STATE OF NORTH CAROLINA
DEPARTMENT OF TRANSPORTATION

Subject: DCM Consistency for the proposed US 70 Havelock Bypass in Craven County. TIP No. R-1015. WBS 34360.1.2.

The North Carolina Department of Transportation (NCDOT) submitted additional information on Havelock Bypass to you on March 13, 2020 for review in regards to the Division of Coastal Management's CAMA Consistency Determination for the project. This package included supplemental information and revised permit drawings. Based on further coordination with the NC Division of Water Resources, further revisions need to be made to this request. This letter is a revised version of the March 13, 2020 request, showing additional and modified information highlighted in red.

PERMIT DRAWING SHEET 93 OF 167

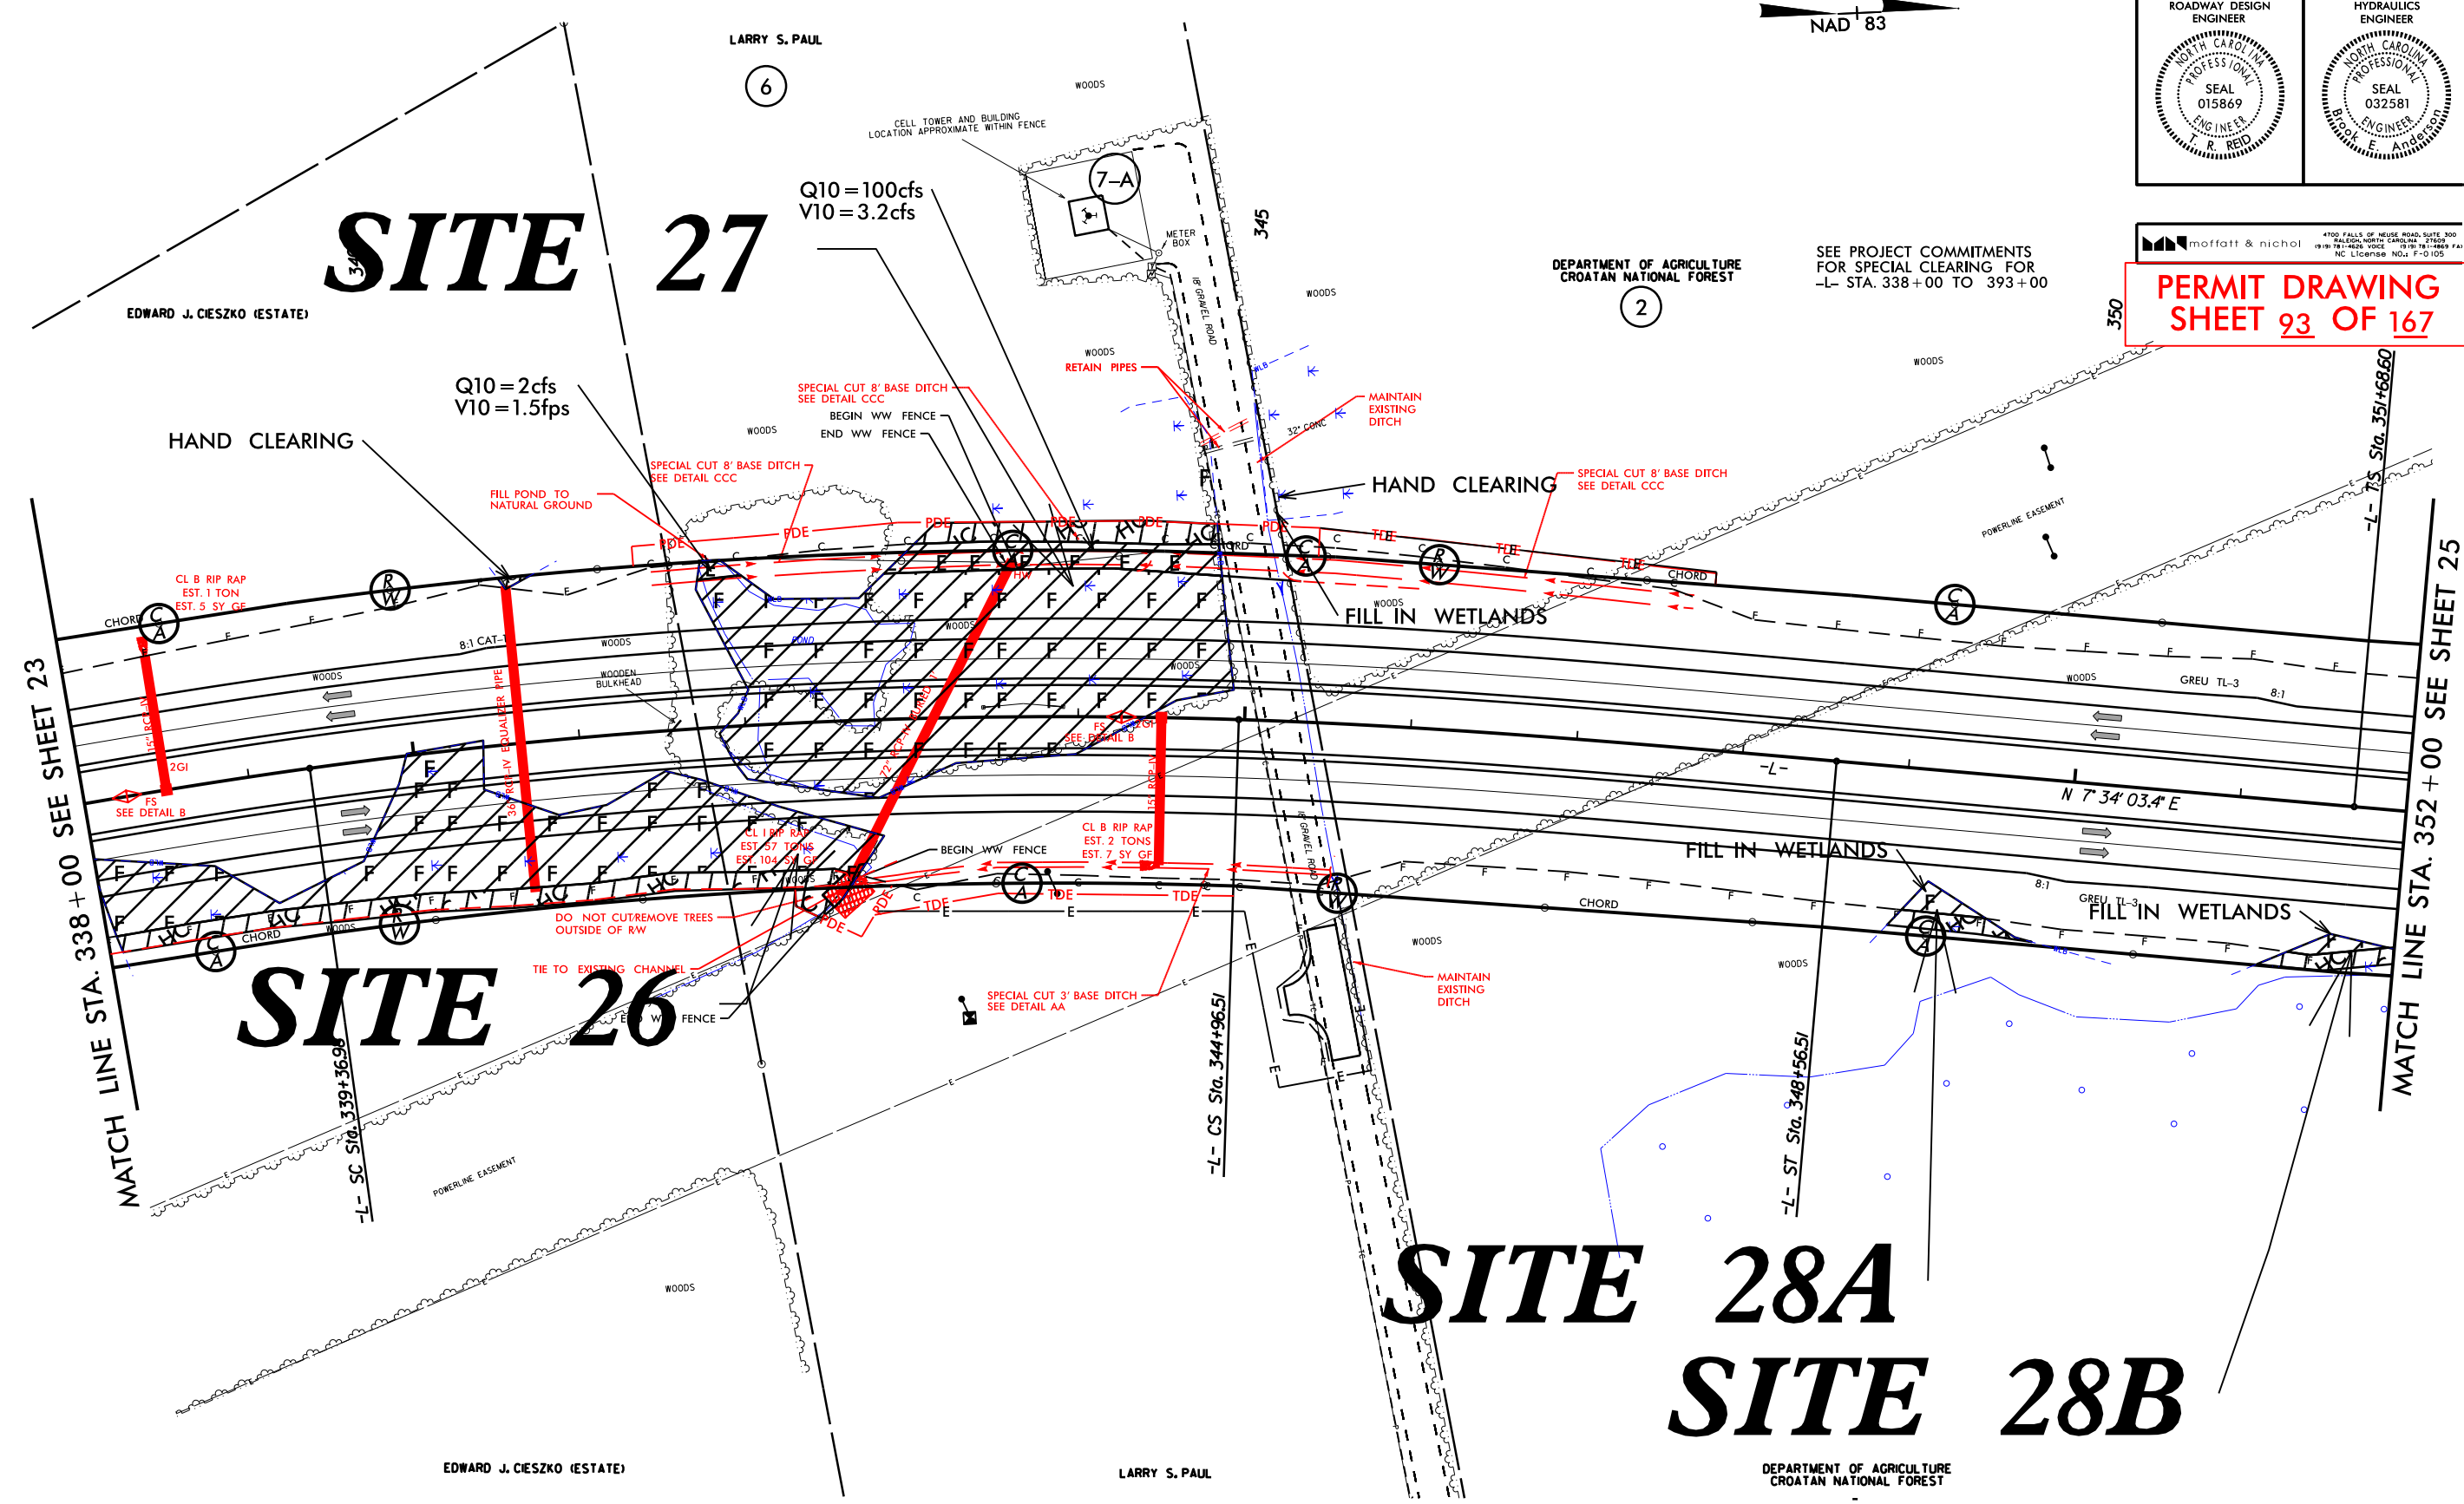
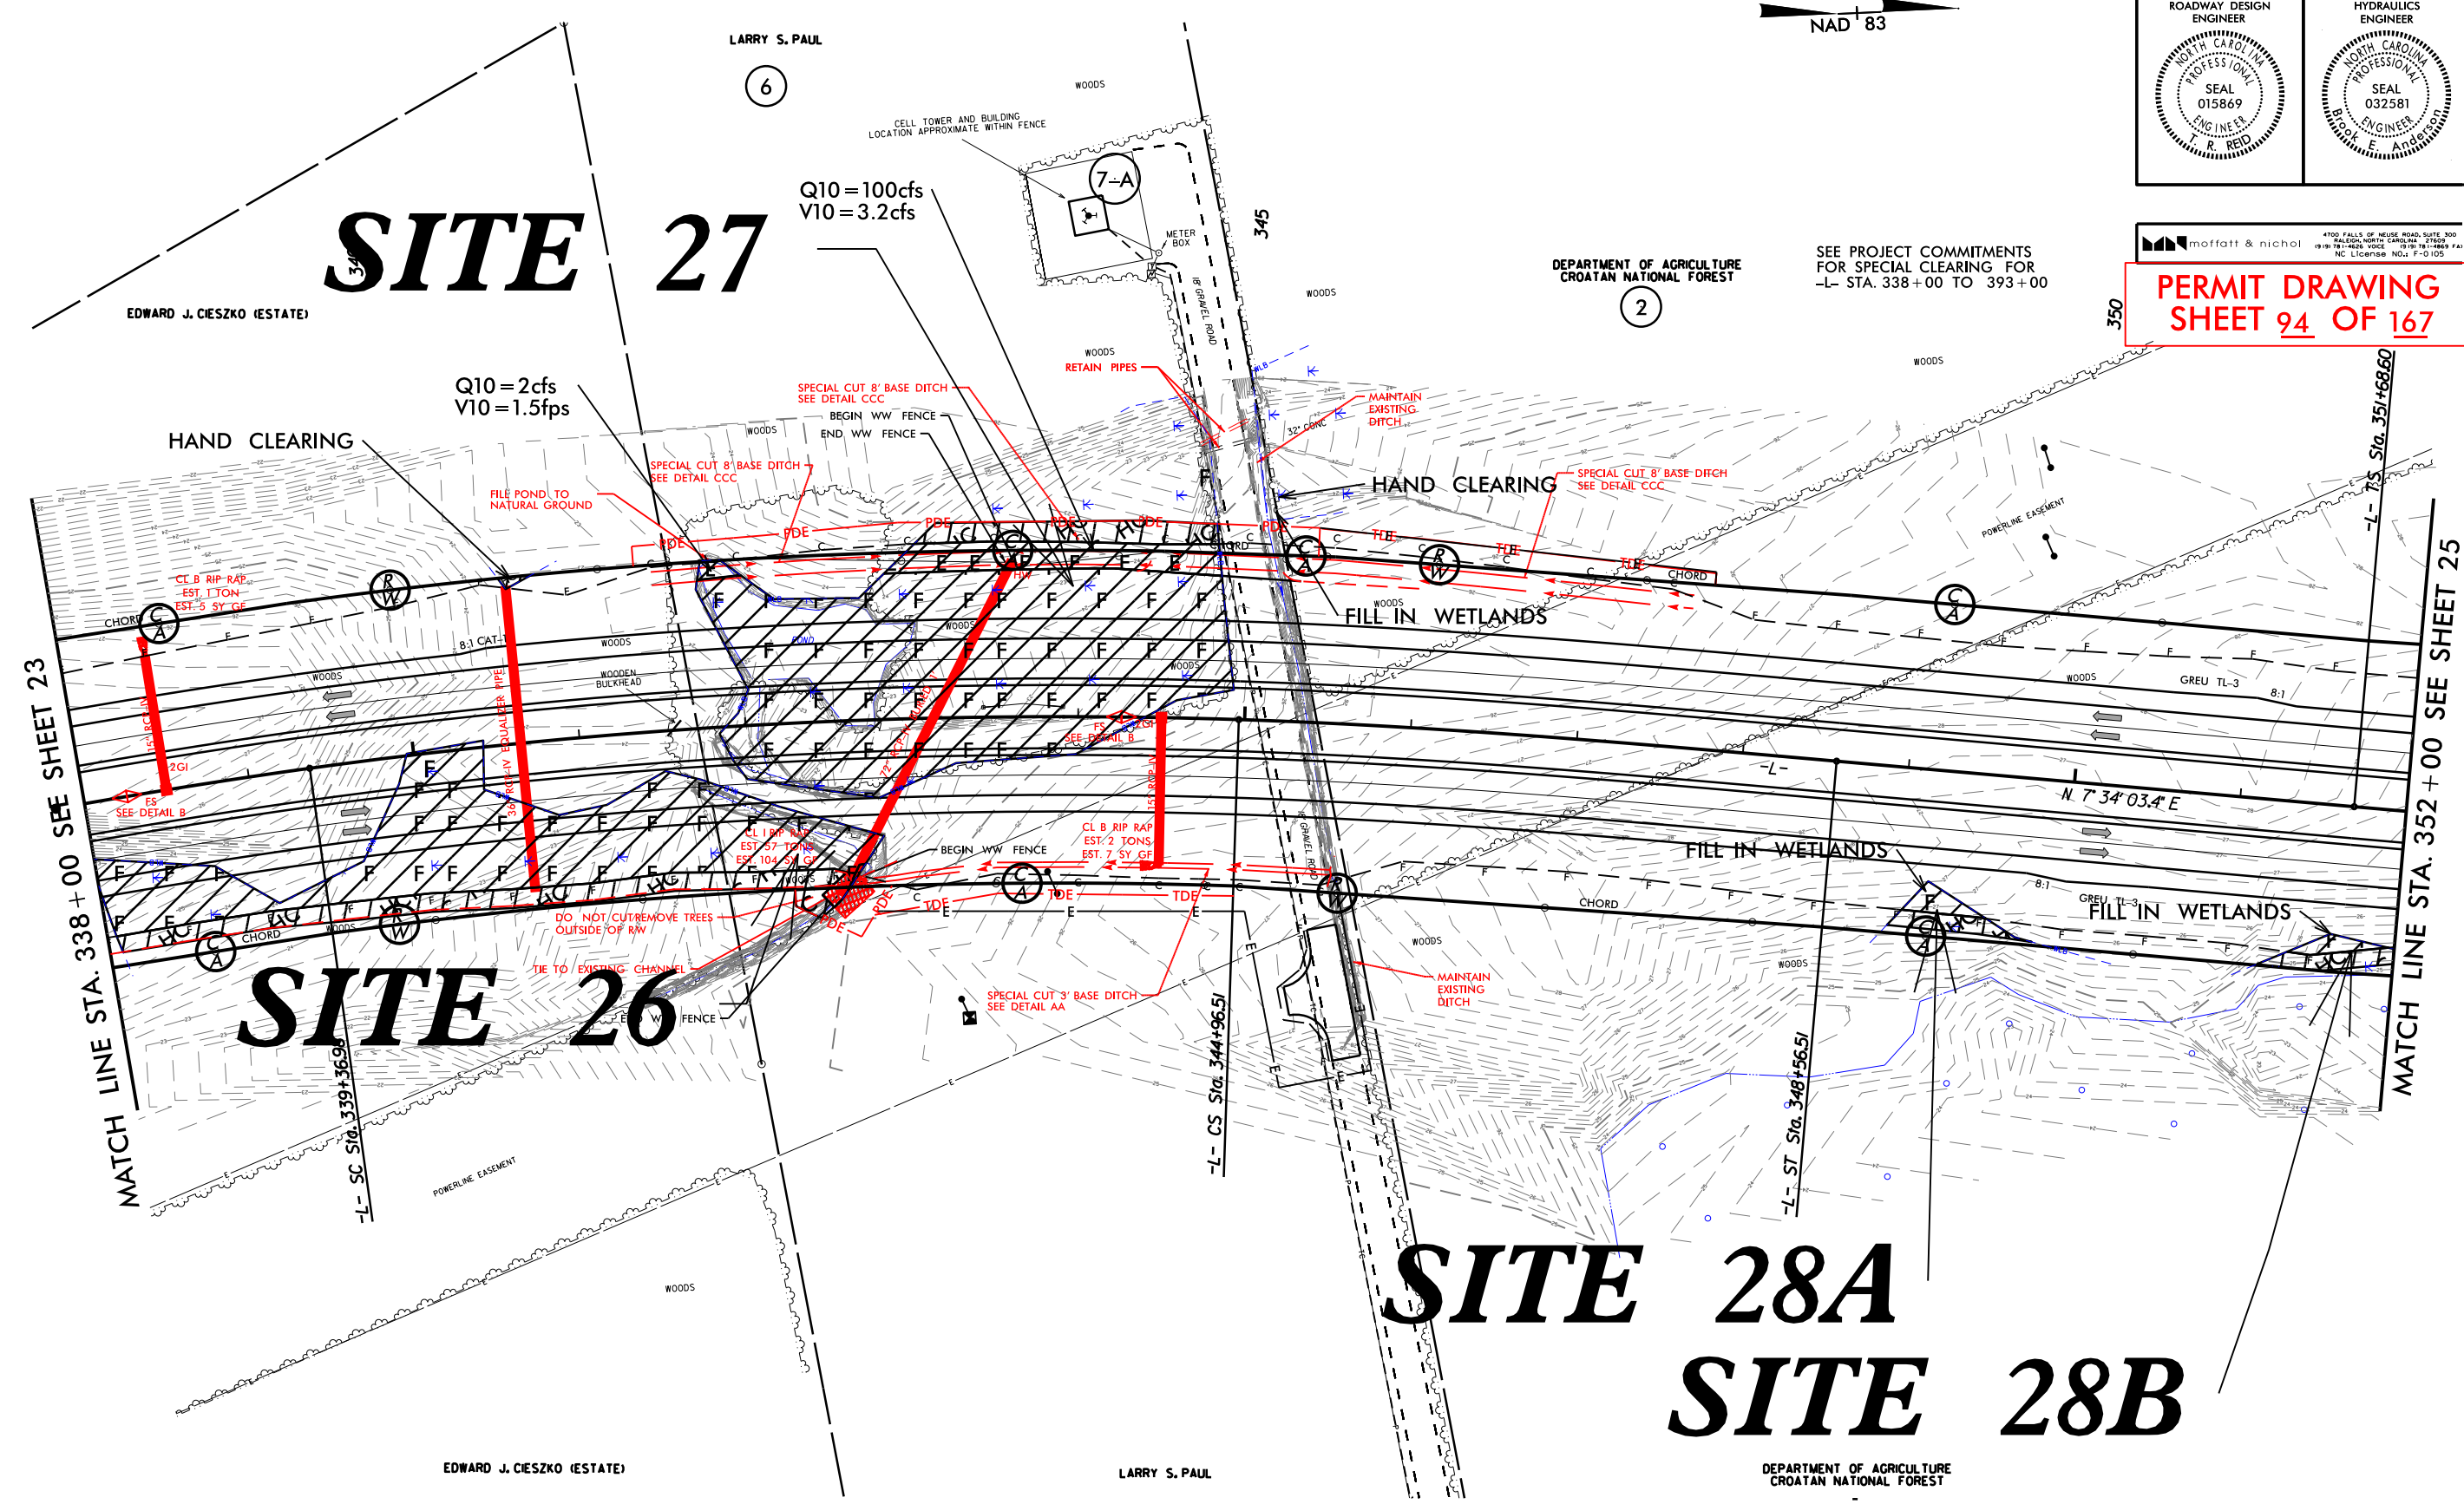
- Site 26: omitted in 3/12/20 modification request, (permit sheets 93 & 94). Slope stake lines were updated due to error in cross slope reported on plan sheets versus cross-sections. Fill in wetlands reduced by 0.01 acre. Hand Clearing increased, but the reported amount did not change.

- Fill decreased by 0.0098 acre, Hand Clearing increased by 0.0076 acre (new = 0.1139 acre, old 0.1063 acre)
- Site 27: omitted in 3/12/20 modification request (permit sheets 93 & 94). Access drive was removed. Fill in wetlands reduced by 0.04 acre. Excavation in Wetlands increased by 0.03 acre. Hand Clearing reduced by 0.01ac.
